Memorandum

Re: **Country Club Acres (aka 190 Mountain Street, East) – Definitive Site Plan Amendment**

Worcester Country Club Acres, LLC seeks a Definitive Site Plan Amendment

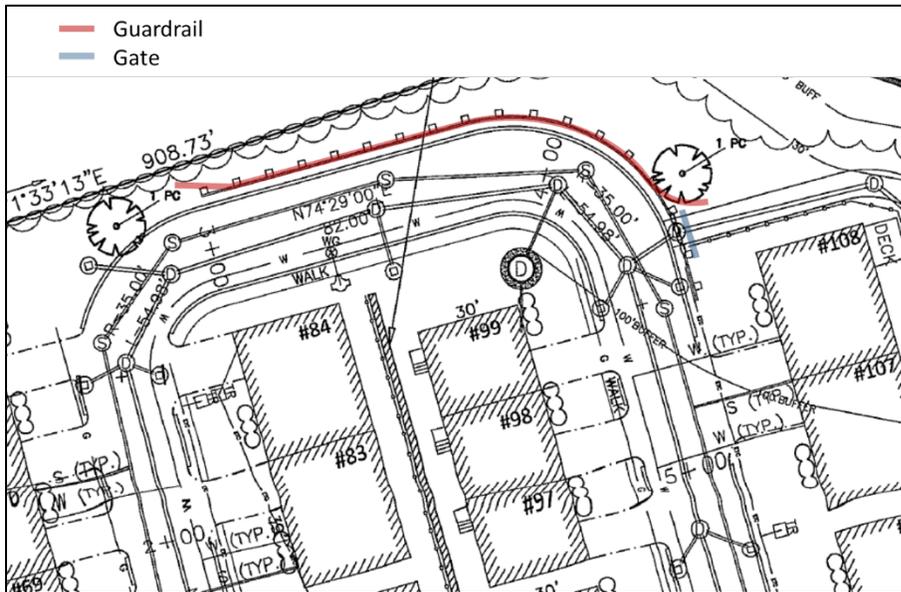
The revised gate configuration, eliminating the driveway median, appears to improve access for emergency vehicles to the site. The applicant should discuss how changes to the gate design effect vehicular access to and movement throughout the site. Please clarify how the new gate is proposed to operate (pin pad, key card, unrestricted, etc.) with a revised design which provides for only one lift/control point.

The guardrail on the northerly portion of Shamy Circle does not utilize an appropriate end treatment (e.g. – taper away from the roadway). Further, interrupting the guardrail with a heavy chain is not a safe or appropriate treatment to provide vehicular access to the detention basin area located below a steep slope with a 90 degree bend along Shamy Circle. Staff recommends that the ends of the guardrail be flared away from the roadway, that the eastern end be tapered around the north side of the access road, and that a separate, heavy-duty gate be installed to control access on the access road (see figure).
